RE: RESPONSE TO REQUEST FOR FURTHER INFORMATION – 21 – 41 CANBERRA AVENUE AND 18 – 32 HOLDSWORTH AVENUE, ST LEONARDS (DA99/2021)

*Construction of five residential flat buildings with a total of 319 apartments,
10 terraces and basement parking.*

Figure 1 – Original Upper Level Setback Arrangement

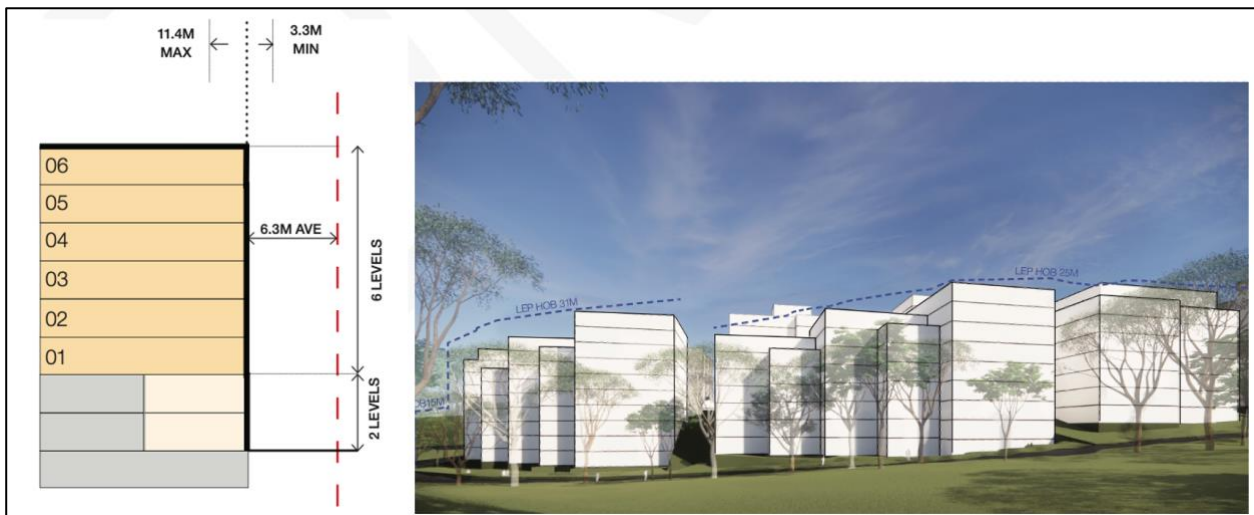
The upper setbacks fronting Canberra Avenue are the outcome of iterative design testing and have been supported by the Lane Cove Council's (Council) Design Excellence Panel. The original scheme presented to Council's NSROC Design Review Panel on the 9 February 2021 proposed a zero metre setback at the upper levels, with an overall consistent setback to Canberra Avenue of 6.3m (refer to **Figure 1**). The design adopted a stepped massing when viewed in plan but not when interpreted in section view.

The NSROC Design Review Panel provided written feedback / meeting minutes dated 9 February 2021 identifying their concern with the mass and scale of the built form when viewed from Newlands Park, noting that:

The Panel remains concerned about the apparent scale and impact of the built form as perceived from Newlands Park. Based on the indicative / illustrative material, it appears that the impact on Newlands Park has not been adjusted at the upper levels to provide for the 'stepping back' of the built form to reflect the initial design criteria.

In response to this feedback, the Applicant amended the upper level setbacks. Following extensive design testing, the design was amended to provide increased upper level setbacks of 3m and an overall average setback of 8.8m to Canberra Avenue. The amendments reduced the perceived bulk and scale of the proposal and provided reduced overshadowing to Newlands Park relative to a complying scheme.

Figure 2 – Revised and Proposed Upper Level Setback Arrangement as Submitted with DA

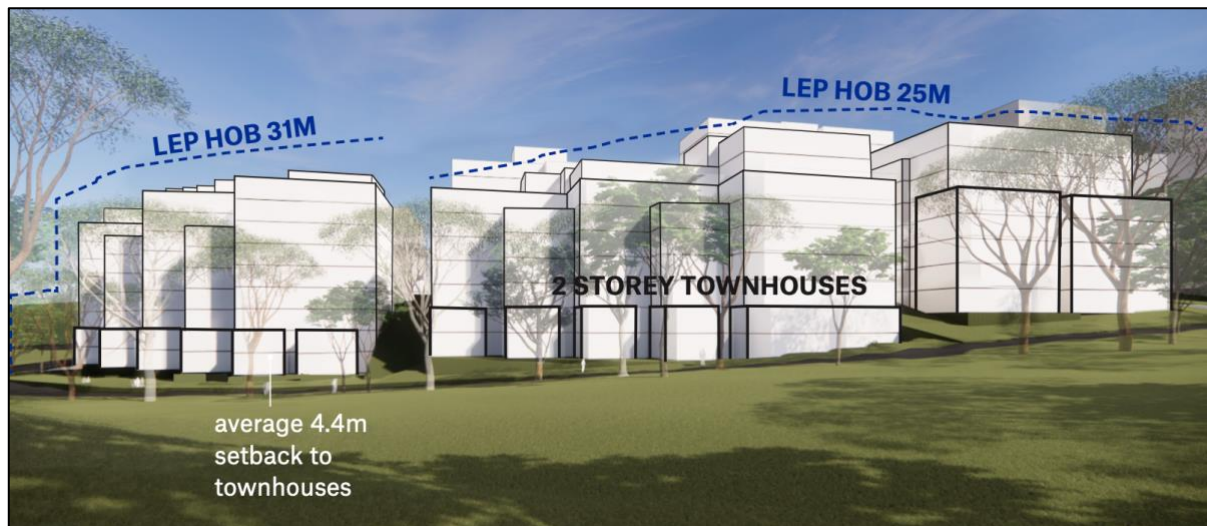
The revised design was reviewed by Council's Design Excellence Panel (the Panel) on 27 April 2021. The minutes from the meeting confirm that the Panel were satisfied with the revised setbacks. Specifically, the Panel noted the following:

The revised massing, materiality, setback of the upper levels and expression of the two storey townhouses located along Canberra Avenue has dramatically improved the overall built form and massing. When viewed from the park and street level, this will help provide human scale to the development.

The design as submitted alongside the Development Application generally maintains the setbacks endorsed by the Panel (refer to **Figure 2**). The detailed merits of the upper level setbacks are addressed in Section 5.1 of the Statement of Environmental Effects (SEE) that accompanied the DA. Since the DA's lodgement, the massing of Building 11 has been slightly amended to reduce the bulk. Specifically, at Level 10 at the top of Building 11 the massing has been reduced due to the conversion of two 3 bedroom units to 2 two bedroom units.

Figure 3 – Fire Assembly Located on Canberra Avenue (Level 4 Floor Plan)

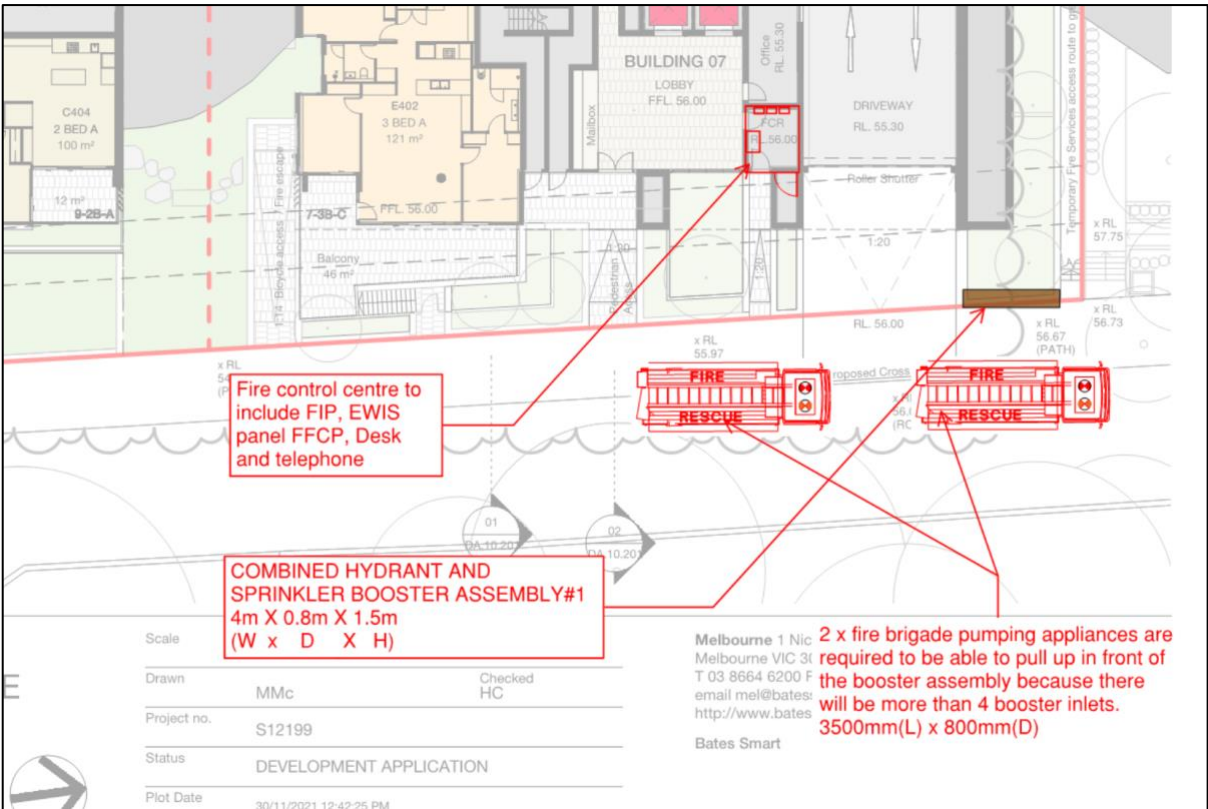
Issue: An indicative fire services location plan should be provided to demonstrate the services have been incorporated into the design of the building. The services should be integrated and their prominence minimised within the streetscape.

IGS have prepared a statement addressing the location of the fire services (refer to **Attachment 9**). As shown in the figure below, the fire services consisting of the fire pump room are now fully integrated with the building. The fire pump room is located within Building 9 and the FCR positioned directly adjacent to the proposed driveway in Building 7. The fire booster is positioned along the northern boundary away from the residential terrace houses. As it is physically separated from the terraces and landscaped front setbacks, it will have minimal visibility when viewed in the streetscape.
